Commonwealth Edison Company

January 19, 1971

Subject: Proposed Change No. 8 to Appendix A
of DPR-19, AEC Dkt 50-237

Pursuant to Section 50.59 of 10 CFR Part 50 and Paragraph 3.B of Facility License DPR-19, Commonwealth Edison hereby submits Proposed Change No. 8 to Appendix A of DPR-19 (Dresden Unit 2). The changes requested in this proposed change are in Sections 1.1 and 2.1 on Fuel Cladding Integrity and in Section 3.2 on Protection Instrumentation. The specific changes are as follows:

Figure 1.1.1. Core Thermal Safety Limit

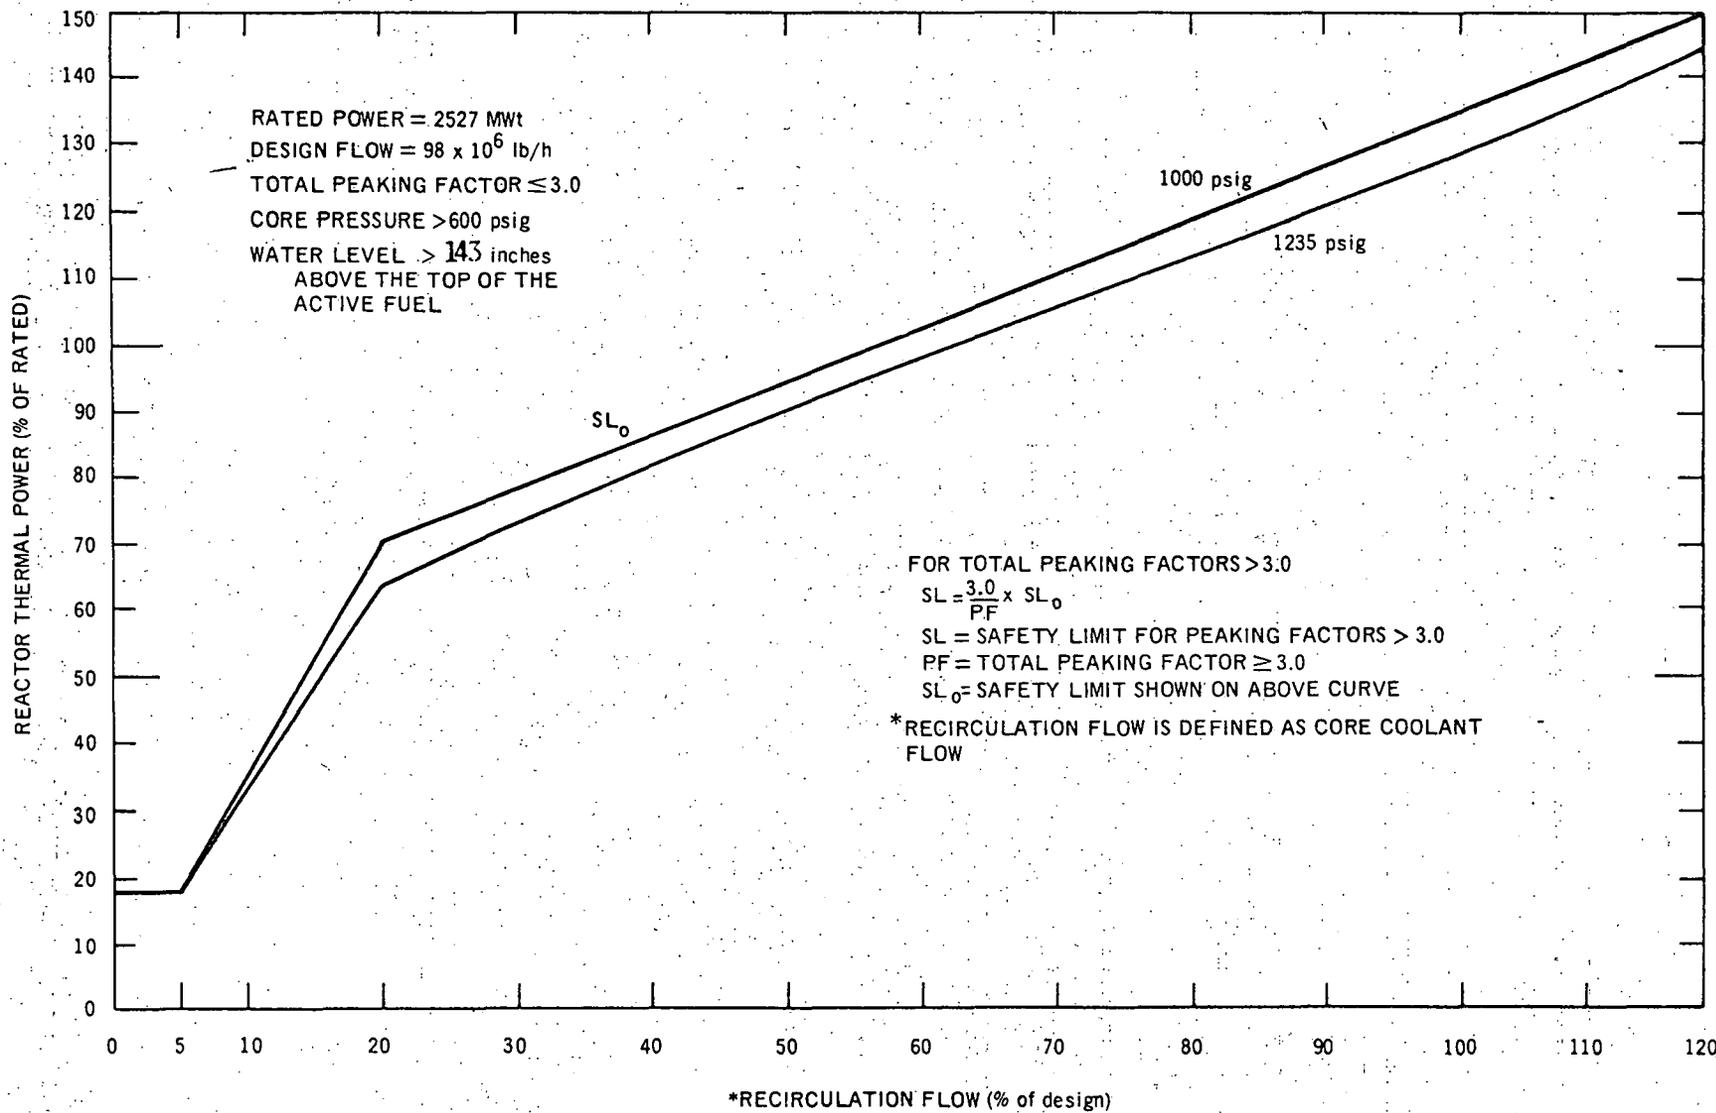
Replace Sections 1.1 and 2.1 (pages 6-23) with new Sections 1.1 and 2.1 (pages 6-19) - attached.

- A. When the reactor pressure is greater than 600 psig the combination of recirculation flow and reactor thermal power-to-water shall not exceed the limit shown in Figure 1.1.1. The safety limit is exceeded when the recirculation flow and thermal power-to-water conditions result in a point above or to the left of the limit line.
- B. When the reactor pressure is less than 600 psig or recirculation flow is less than 5% of design, the reactor thermal power-to-water shall not exceed 460 MW(t).
- C. 1. The neutron flux shall not exceed the scram setting established in Specification 2.1.A for longer than 1.5 seconds as indicated by the process computer.
2. When the process computer is out of service, this safety limit shall be assumed to be exceeded if the neutron flux exceeds

The safety limit curves shown in Figure 1.1.1 represent the locus of operation conditions for which the maximum powered rod has a minimum critical heat flux ratio (MCHFR) equal to 1.0. The MCHFR value was determined using the design basis critical heat flux correlation given in APED 5286⁽¹⁾. The operating range with MCHFR >1.0 is below and to the right of these curves. The evaluation is based on the operating map as given in Figure 3.2.3 of the SAR.

Figure 2.1.1. APRM Flow Reference Scram and APRM Rod Block Settings

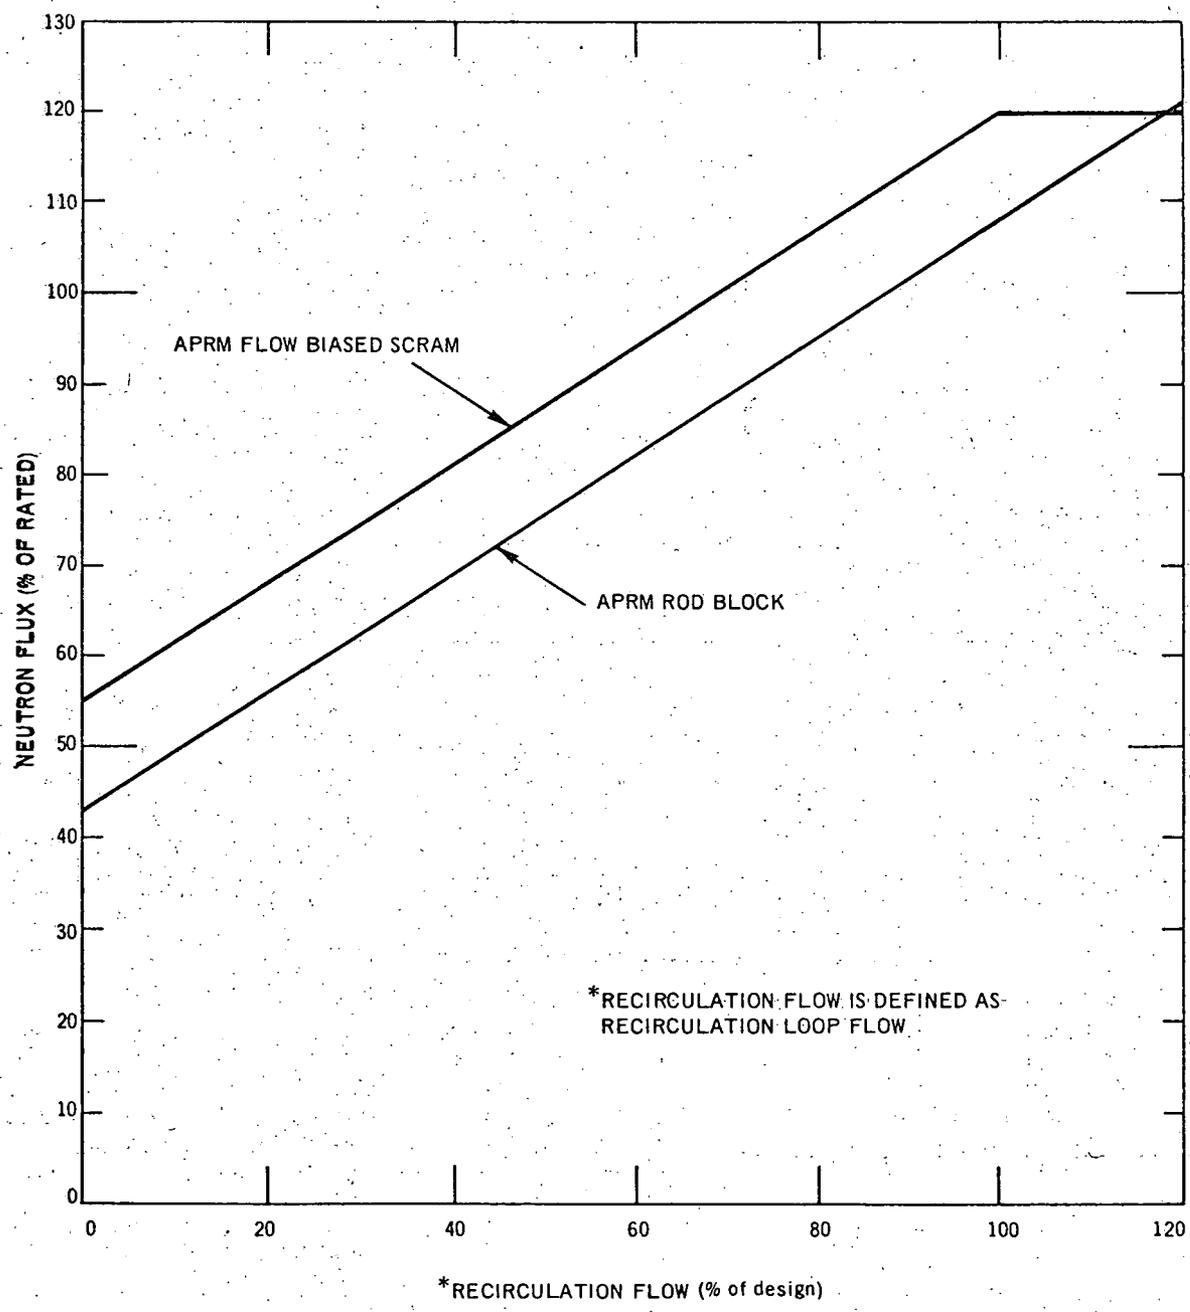
1. APRM - The APRM flux scram setting shall be as shown in Figure 2.1.1 unless the combination of power and peak heat flux is above the curve in Figure 2.1.2. When the combination of power and peak heat flux is above the curve in Figure 2.1.2 a scram setting(s) as given by:

- B. APRM Rod Block — The APRM rod block setting shall be as shown in Figure 2.1.1 unless the combination of power and peak heat flux is above the curve in Figure 2.1.2. When the combination of power and peak heat flux is above the curve in Figure 2.1.2 a rod block trip setting (SRB) as given by:
